1 7/21/2021 1ST REVIEW FROM TOWN OF ROLESVILLE CONSULTANT, WAKE COUNTY OF KALEIGH

KALAS FALLS
PHASE 3
32 ROLESVILLE ROAD
WAKE COINTY NO

DATE: FEB 18, 2021
SHEET TITLE:
PHASE 3
UTILITY
PLAN

HGL=25YR

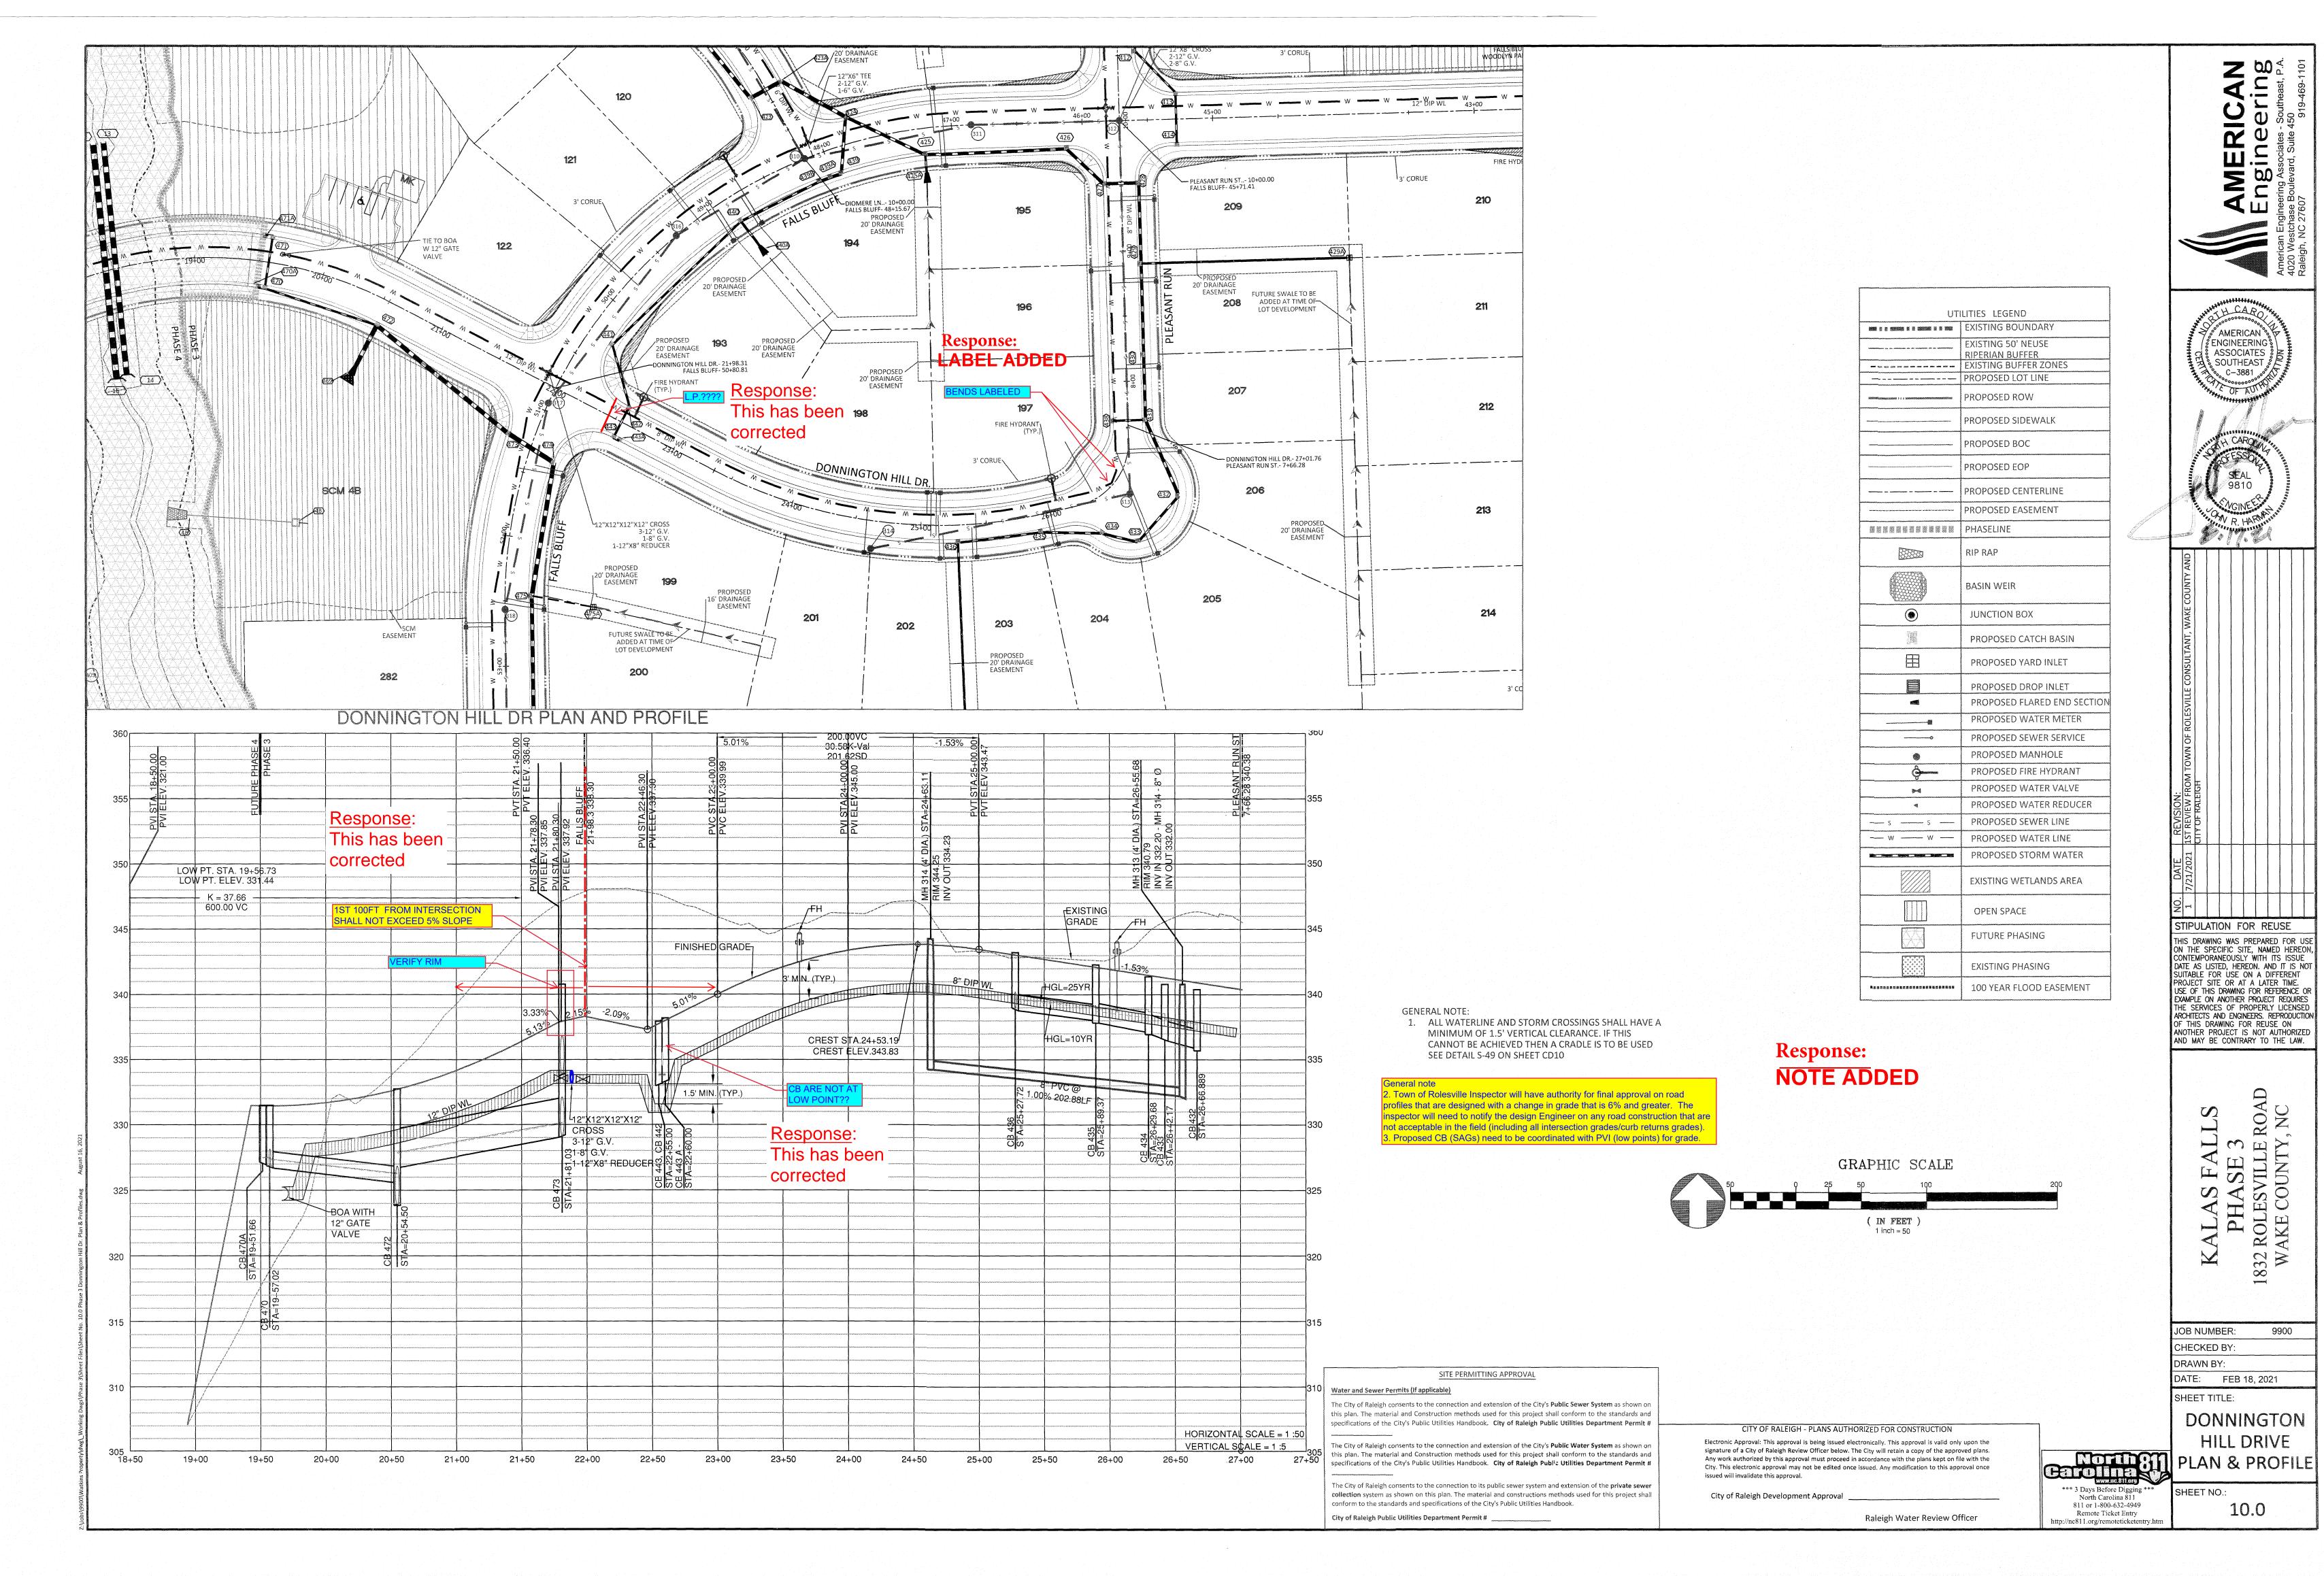
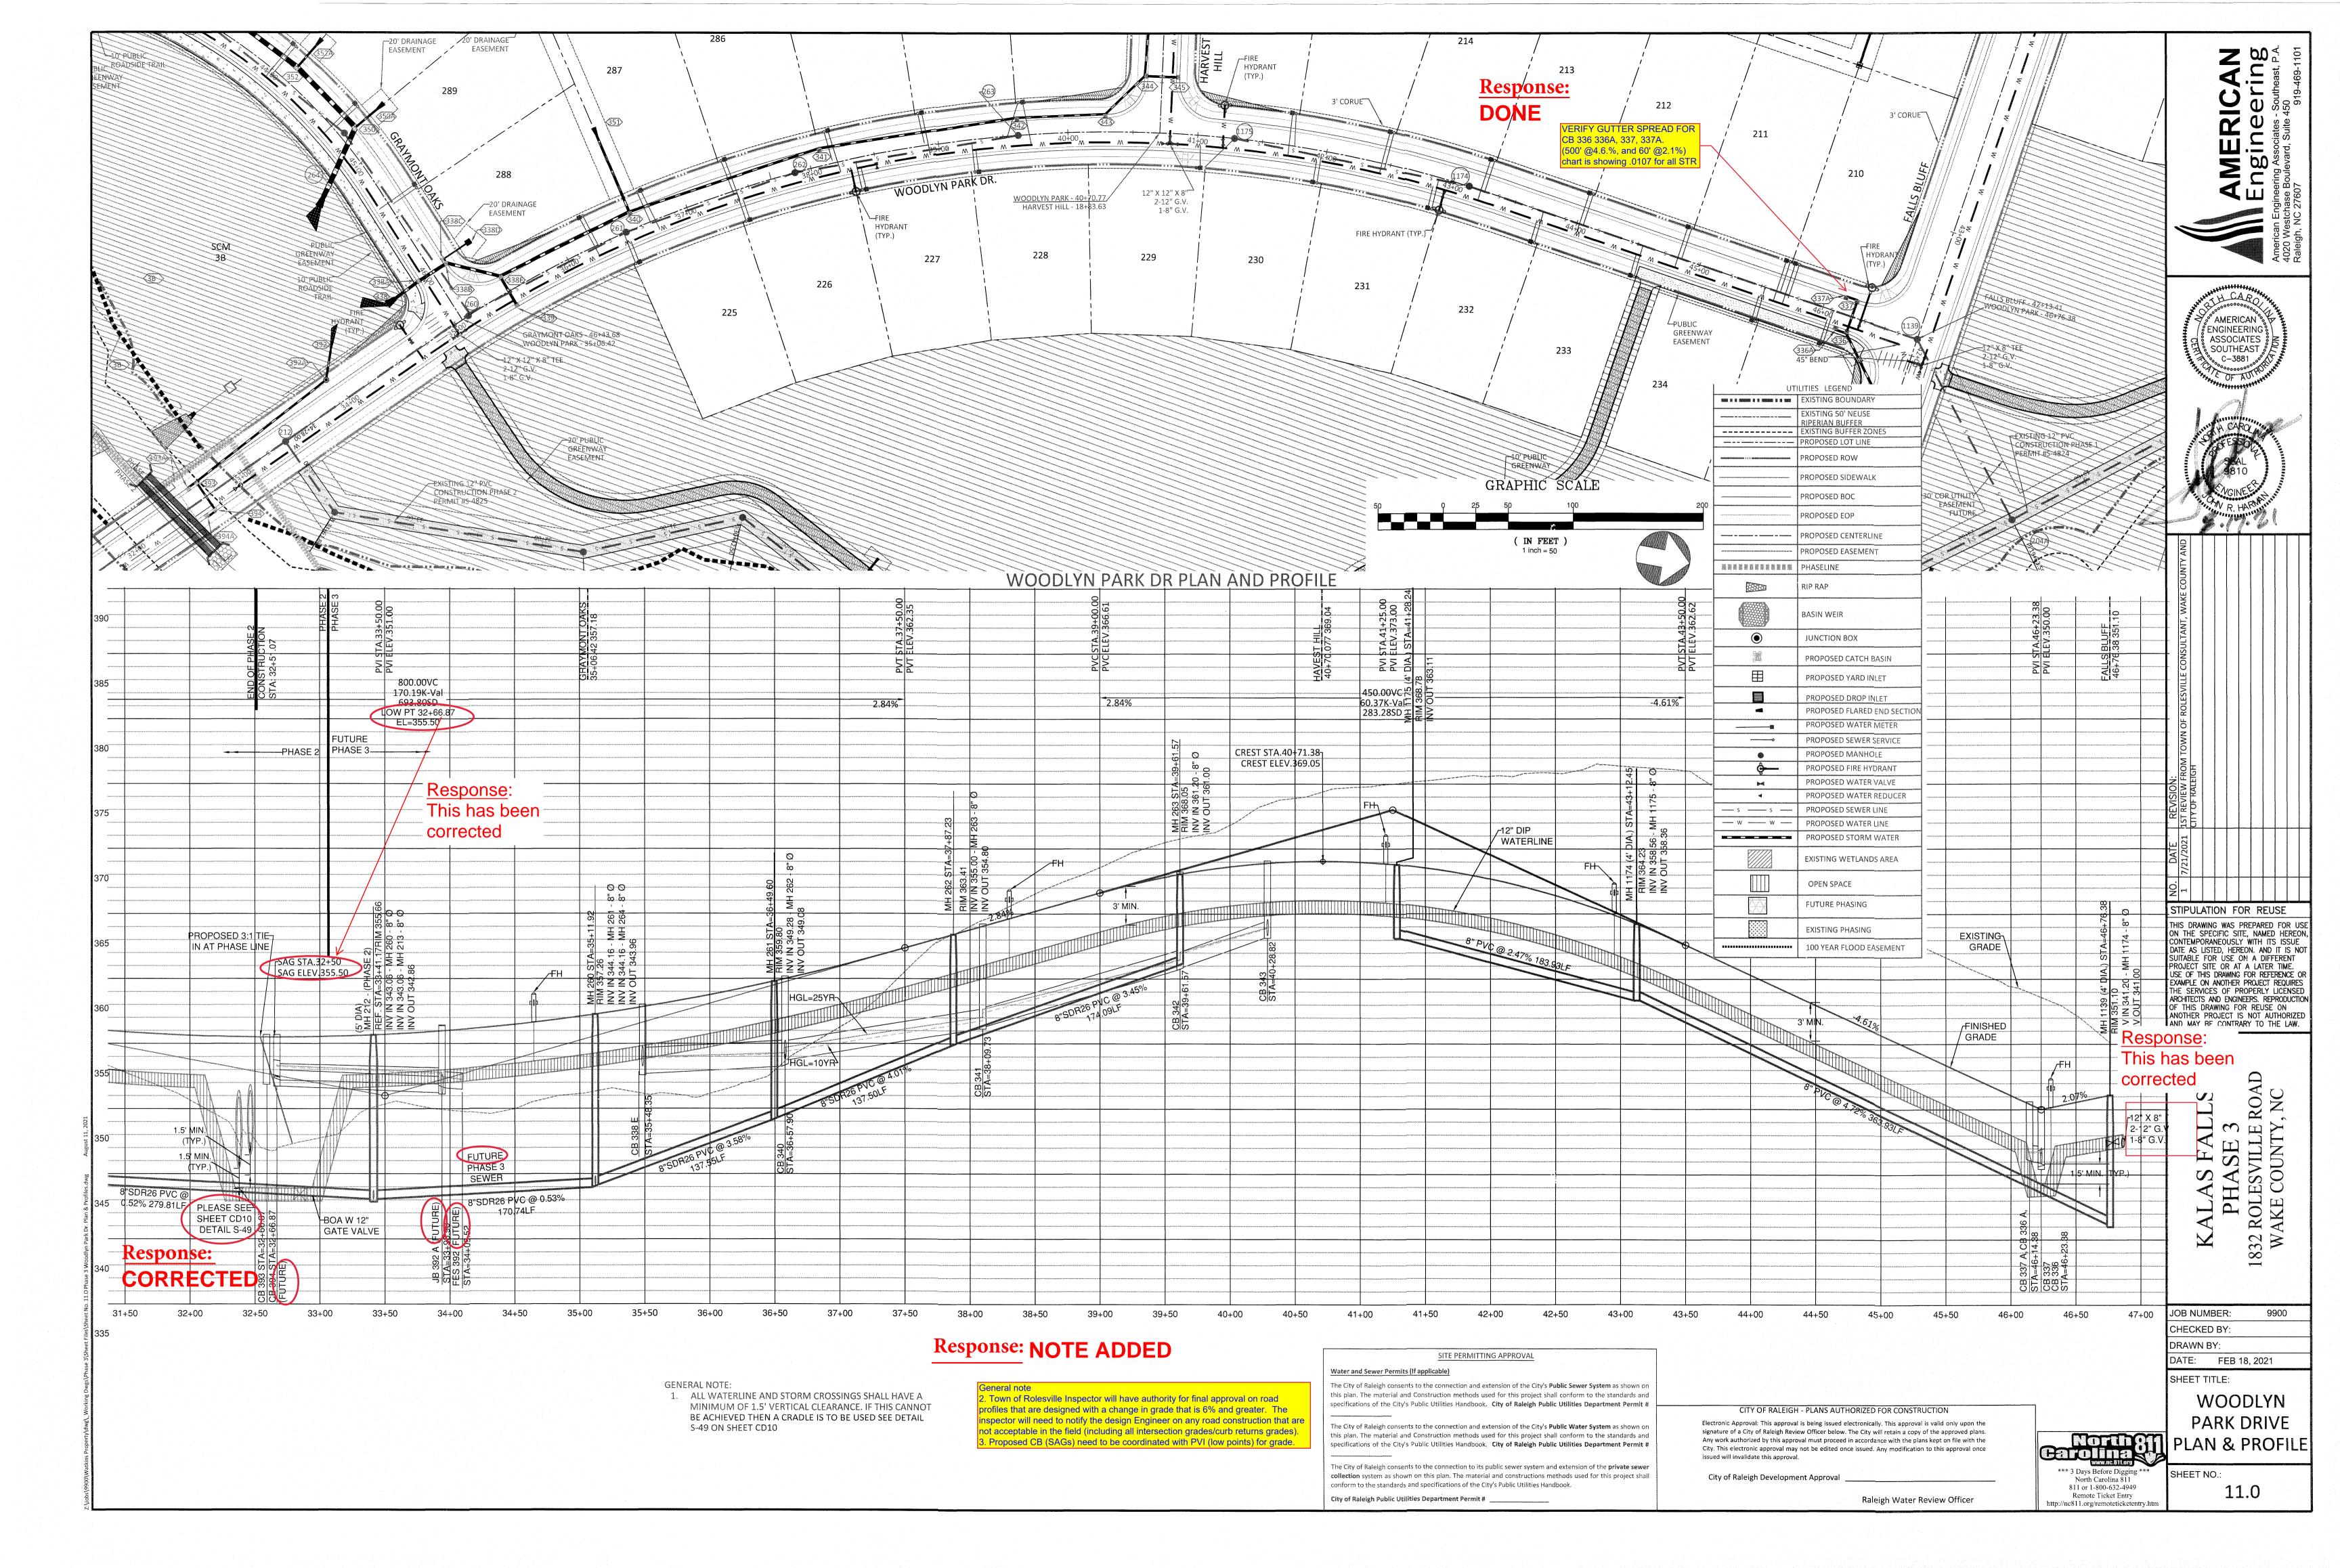
-1ST 100FT FROM INTERSECTION SHALL NOT EXCEED 5% SLOPE Response: This isnt (WHEN ROAD LESS THAN 500', needed per SLOPE MAY BE 150% GREATER) - 7.5% MAX SLOPE FOR 1ST 100 FT conversation the week of 8-26.

> **Response: FIXED**

Response: NOTE HAS BEEN ADDED
